Staff Report & Recommendation

Historic Preservation Board

HPB19-0365, 1225 & 1235 Lenox Avenue.

1235 Lenox Avenue, 1989 Photograph, Historic Properties Database Card

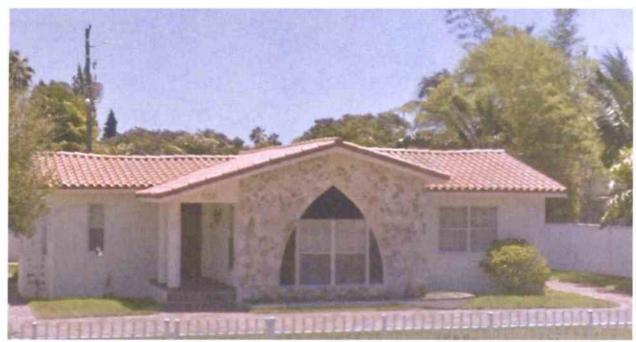
After review of the engineer's assessment, staff believes that it is unlikely the existing residence could be renovated and brought into compliance with the current Florida Building Code without a near total demolition and reconstruction. However, staff would not recommend this option for several reasons. First, sufficient documentation to reconstruct the home in accordance with its original design has not been located. No original plans for the subject house have been found and only one photograph from 1989 is available.

Further, the Secretary of Interior's Standards for the *Treatment of Historic Properties with Guidelines for Preserving, Rehabilitating, Restoring & Reconstruction of Historic Buildings* published by the U.S. Department of Interior, National Park Service 2017, only recommends reconstruction be considered as a treatment "when a contemporary depiction is required to understand and interpret a property's historic value (including the re-creation of missing components in a historic district or site); when no other property with the same associative value has survived; and when sufficient historical documentation exists to ensure an accurate reproduction. Additionally, the reconstruction of the building in its existing condition would not be possible, as the finish floor would be required to be raised approximately 3.2 feet to meet current base flood elevation requirements. Further, the previously existing structure did not comply with current setback requirements.
